TECHNICAL MEMORANDUM

WETLAND A DESIGN REVIEW

To	Southern Links 1 project team	From	Mark McVinnie, David MacPherson
Attention	c/o Dillon Kelliher (Colliers Project Leaders)	Date	28 August 2026
Email	[REDACTED]	Reference	HAM2025-0056AK Rev 4
Cc		Pages	8 (excluding the appendices)
Subject	Wetland A Design Review

PROPOSED - Section - A2 CH 0+00.00 TO CH 0+71.89
SCALE: 1:750 H / 1:150 V

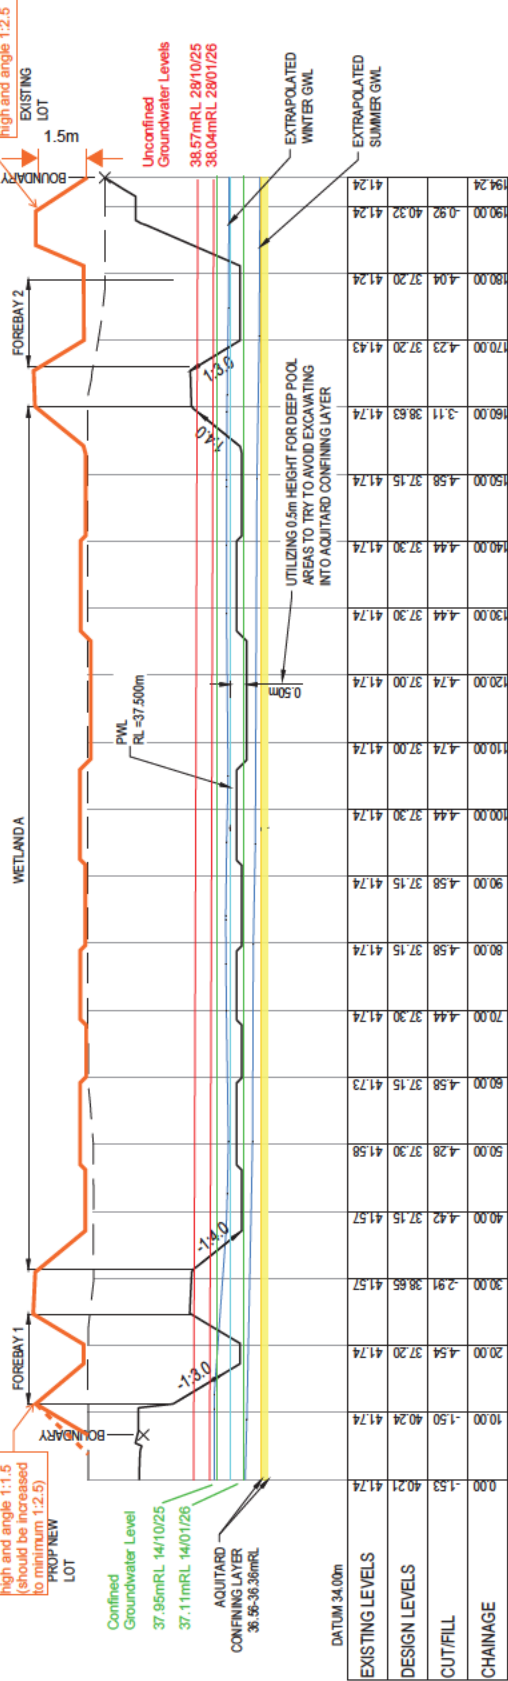
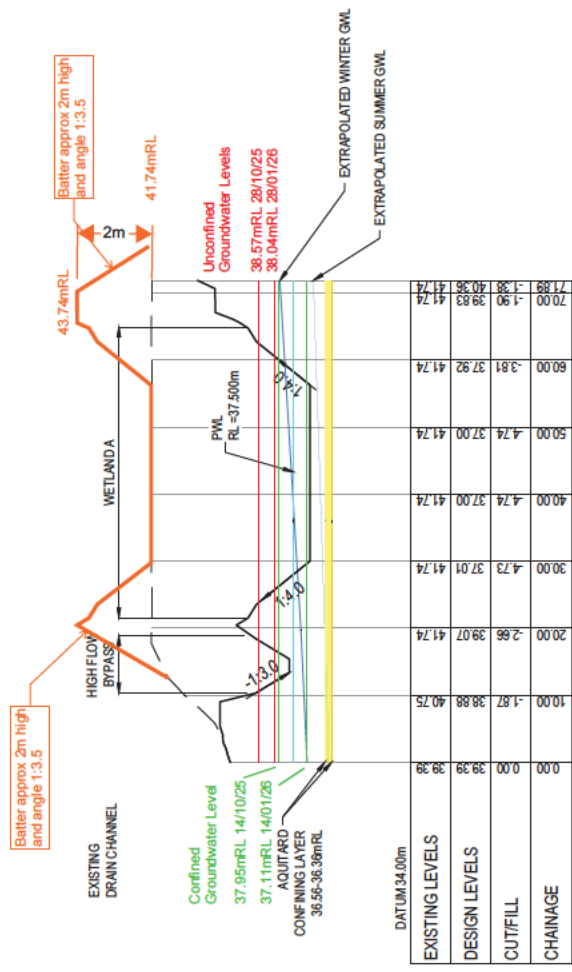
Batter approx 1.5m high and angle 1:1.5 (should be increased to minimum 1:2.5) PROPOSED LOT

Confined Groundwater Level
37.95mRL 14/10/25
37.11mRL 14/01/26
AQUITARD CONFINING LAYER
36.56-36.36mRL

Option 1: Raised SW Bunds
CMW draft markup for discussion
(shown in orange)

PROPOSED - Section - A2 CH 0+00.00 TO CH 0+71.89
SCALE: 1:750 H / 1:150 V

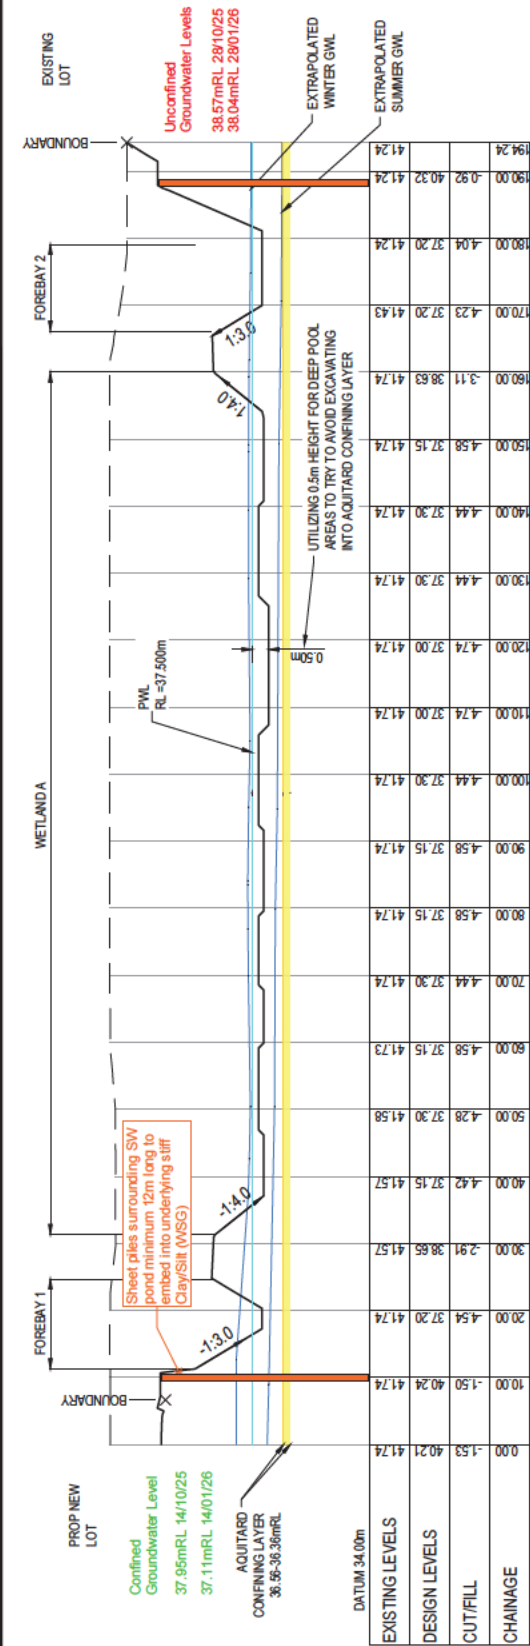
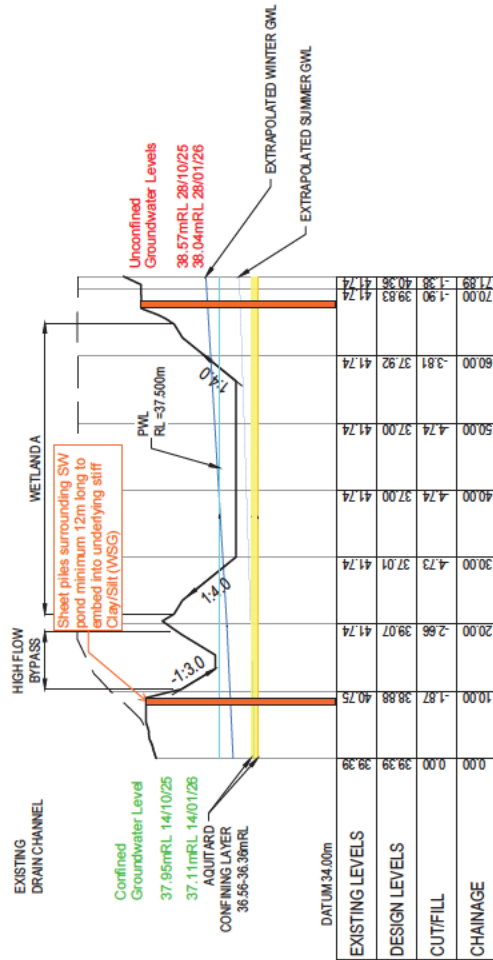
Option 3: Sheet Piles
CMW draft markup for discussion
(shown in orange)
